IREDELL COUNTY HEALTH DEPARTMENT

PERMIT # 239749

SEPTIC IMPROVEMENT PERMIT / AUTHORIZATION TO CONSTRUCT / OPERATION PERMIT / EXISTING SYSTEM

SITE ADDRESS: 138 Trailway Drive, Statesville, NC 28625

INITIAL SITE SKETCH

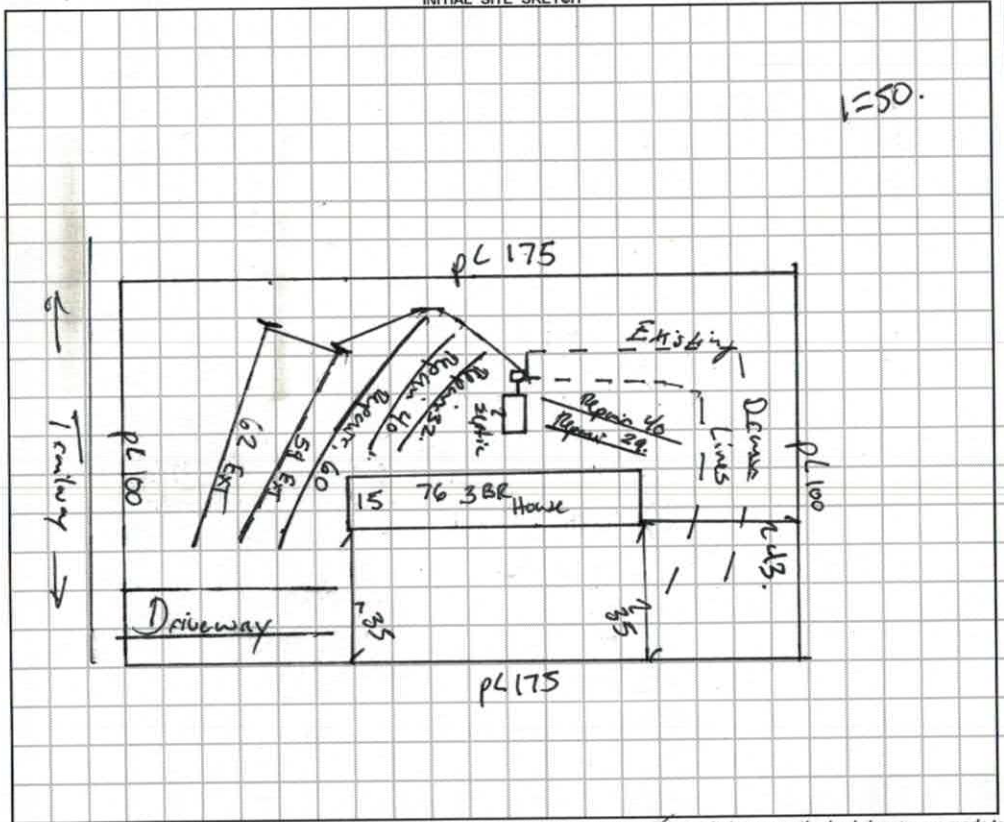
Comments / Conditions: Purpose of this permit is to show new home location and New Repair Area. Water Line must be 10 ft from any Septic Component. No Foundation Drains may be installed.

24 4' Infiltrators Installed
13 in Topline
11 in bottom
Installed @ 24"

- Waterline moved to Right side of Driveway

INITIAL SITE SKETCH

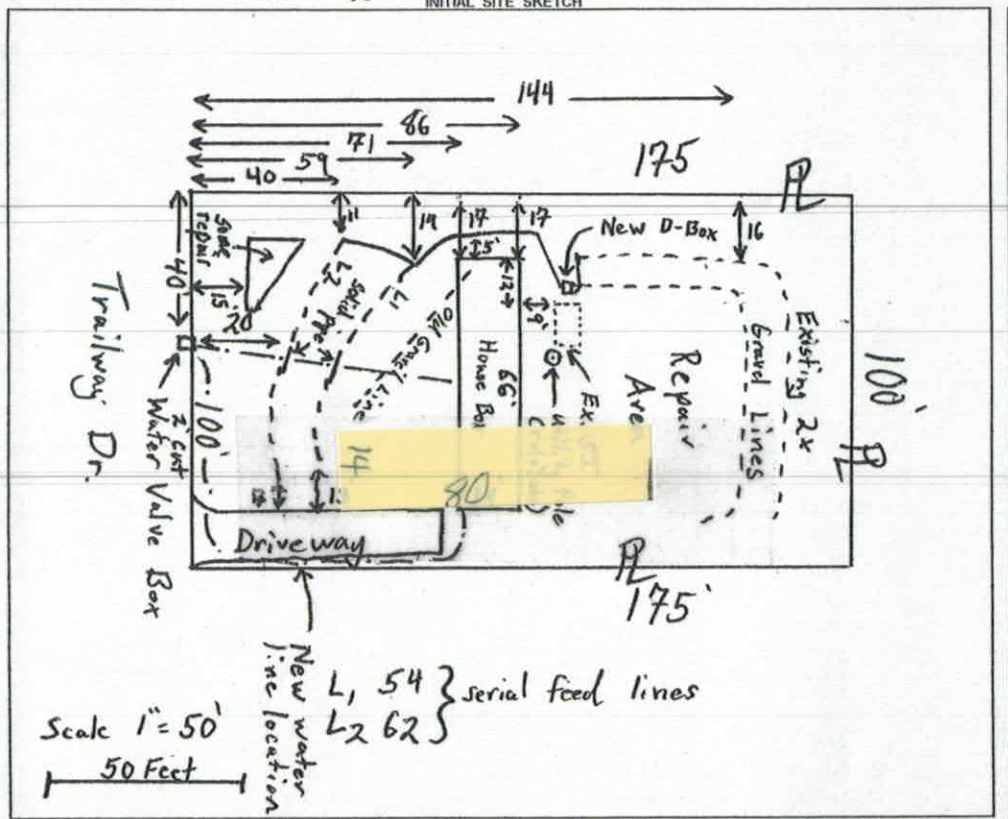
Comments / Conditions: * Though 116 l.f. of line has been laid out, only 100 l.f. need be installed * solid pipe at least 2' to either side of old H_2O line. Re-route water line around drainfield area. Relocate existing utility pole (currently 4 feet from Septic tank) at least 5 feet from all septic components. New D-Box to distribute 2/3 of flow to existing field and 1/3 to new lines. NO FOUNDATION DRAINS TO BE INSTALLED! Recommend pumping septic tank every 3-5 years (replace if needed) [tank not uncovered/inspected at time of site visit 12/4/18].

M/H IS PERMITTED TO BE TURNED LENGTHWAYS PER R10(C) OF CODE.

INITIAL SITE SKETCH

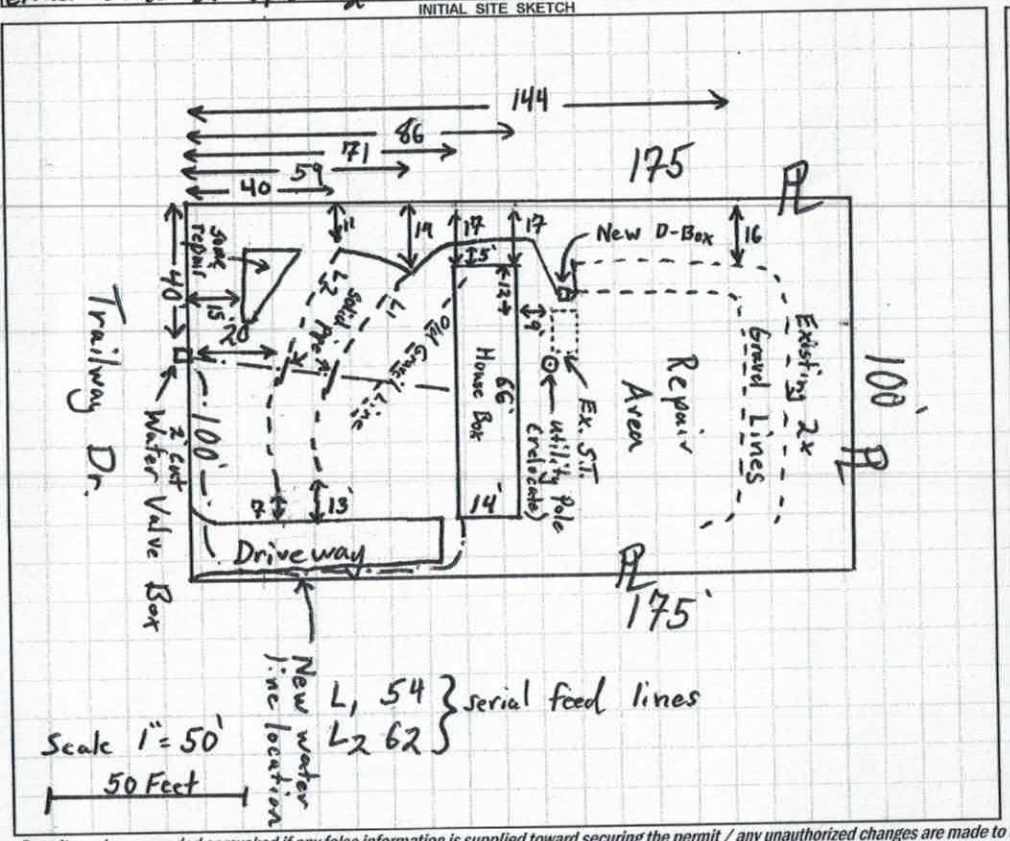
Comments / Conditions: * Though 116 l.f. of line has been laid out, only 100 l.f. need be installed * solid pipe at least 2' to either side of old H_2O line. Re-route water line around drainfield area. Relocate existing utility pole (currently 4 feet from septic tank) at least 5 feet from all septic components. New D-Box to distribute 2/3 of flow to existing field and 1/3 to new lines. NO FOUNDATION DRAINS TO BE INSTALLED! Recommend pumping septic tank every 3-5 years (replace if needed) [tank not uncovered/inspected at time of site visit 12/4/18].

WAITING ON WATERLINE TO BE RELOCATED AND VERIFIED WILL SIGN OP ONCE IT IS CALLED BACK IN 1-9-19 BCW

2 4' INFILTRATOR INSTALLED
13 IN TOP LINE
11 IN BOTTOM
INSTALLED AT 24"
